Service Advisory

MTD-092

Models Affected: OEM-190-032 and 190-032-101
Serial Number Range Affected: N/A
Date: 10/01/2008
Subject: 42" 2-Stage Snow Thrower Attachment Heat Shield

FIGURE 1

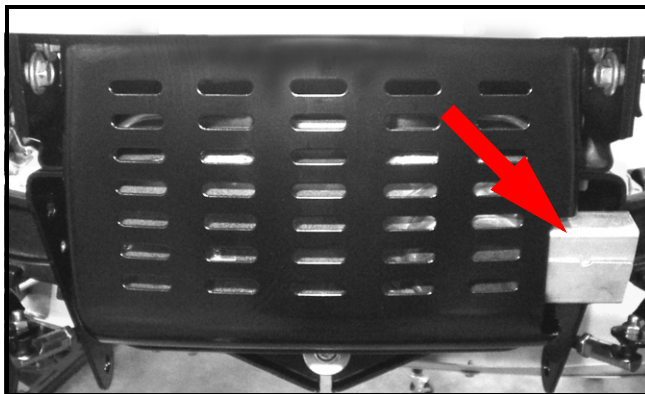
For riders that have the raised side discharge muffler, see Figure 1, the snow thrower's heat shield, see Figure 2, is not required. The heat shield should be removed before attaching the snow thrower attachment to the rider.

FIGURE 3

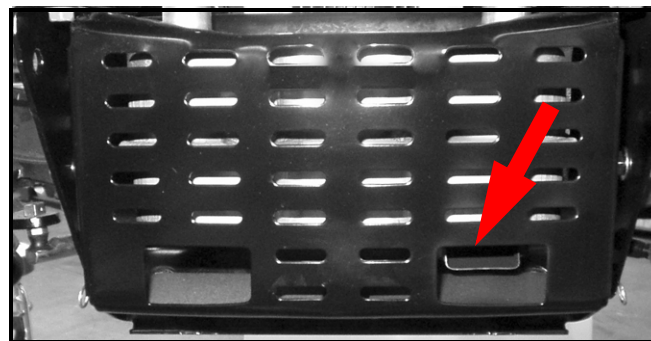
For riders that have the lower forward discharge muffler, see Figure 3, the snow thrower's heat shield must remain on the snow thrower attachment to protect the gear box.
